Access Compliance Report Public Rights-of-Way (Curb Ramps)

Main Street: LA_CANADA_WAY Cross Street: IRVINE_AVE Location: N

ADA ID: RPRK211018120552 Ramp Type: Type 4 - Parallel Initial Pass/Fail: Fail Overall Compliance: No Severity Score: 16

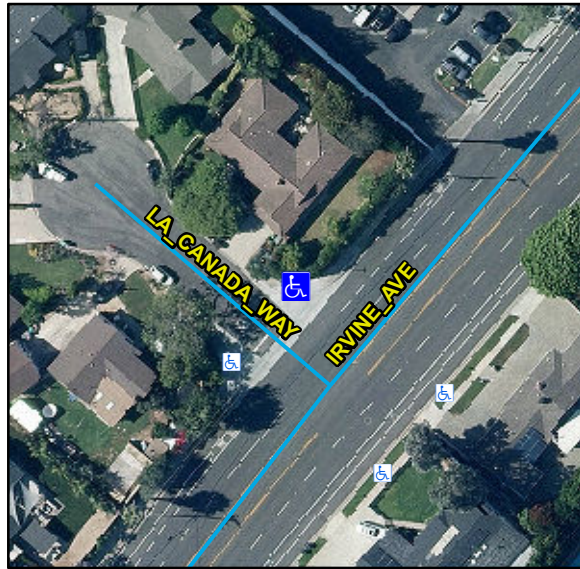
R304.3.2, R304.5.3, STD 1115

Compliance	Description	Data	Compliance	Description	Data
N/A	Ramp Length LT (in)	122	N/A	Ramp Length RT (in)	118
Yes	Ramp Width LT (in)	77	Yes	Ramp Width RT (in)	82
No	Ramp Run Slope LT (%)	10.2	Yes	Ramp Run Slope RT (%)	1.9
No	Ramp Cross Slope LT (%)	2.2	Yes	Ramp Cross Slope RT (%)	1.2
N/A	Landing Present	N/A	N/A	DWS Provided	N/A
N/A	Landing Length (in)	N/A	N/A	DWS Contrast	N/A
N/A	Landing Width (in)	N/A	N/A	DWS Length (in)	N/A
N/A	Landing Run Slope (%)	N/A	N/A	DWS Full Width	N/A
N/A	Landing Cross Slope (%)	N/A		DWS Offset Type	N/A
N/A	Landing Movement Obstructed?	N/A	N/A	DWS Offset Left (in)	N/A
	Landing Movement Type	N/A	N/A	DWS Offset Right (in)	N/A
N/A	Landing Shared	N/A			
N/A	Clear Space	Yes			
N/A	Clear Space To Crosswalk (in)	N/A			
N/A	Marked Crosswalk 1	No	N/A	Marked Crosswalk 2	No
	Crossing 1 Direction	SW		Crossing 2 Direction	SE
	Marked Crosswalk 1 Width (in)	N/A		Marked Crosswalk 2 Width (in)	N/A

Remove & Replace Curb Ramp With Two New Directional Ramps or Equivalent.
